UN6GHz PRE-APPROVAL GUIDANCE CHECKLIST

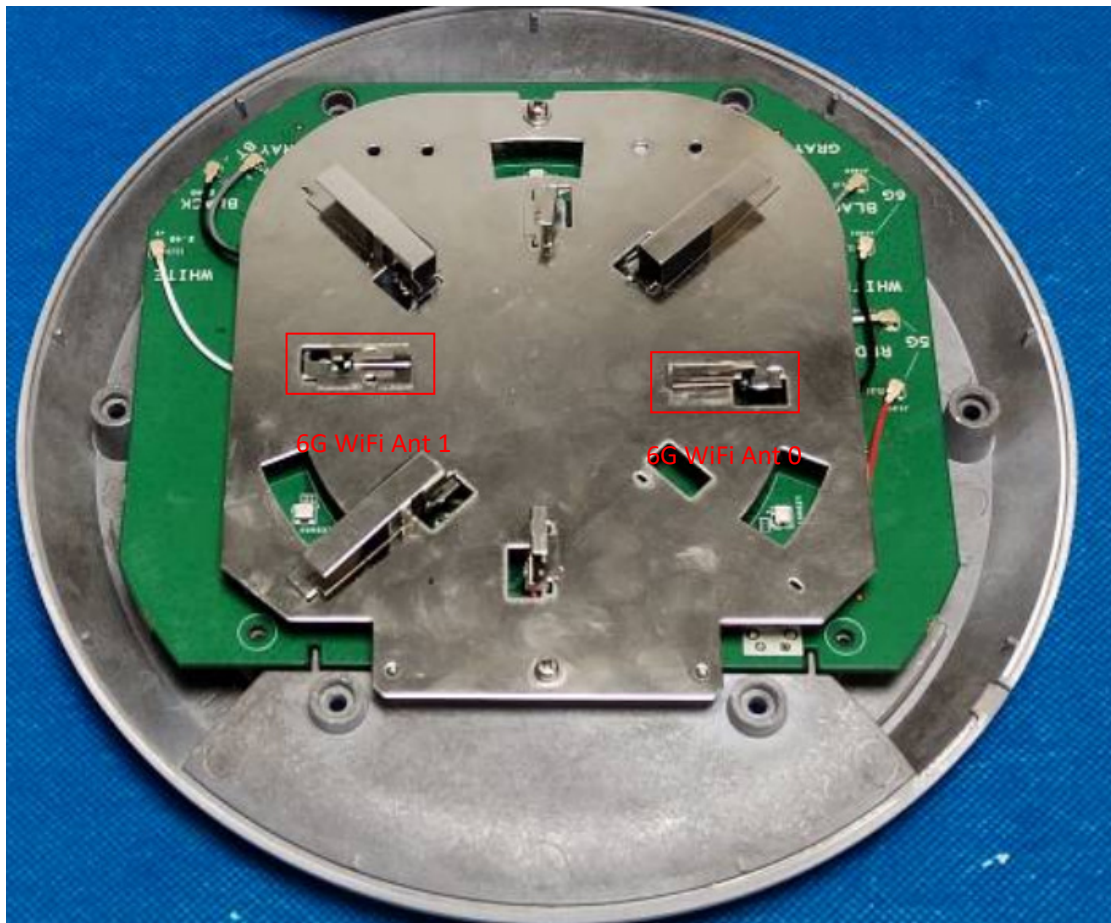
7.1 Label showing indoor only for Subordinate and APs.

Reply: Please refer to the label as below:
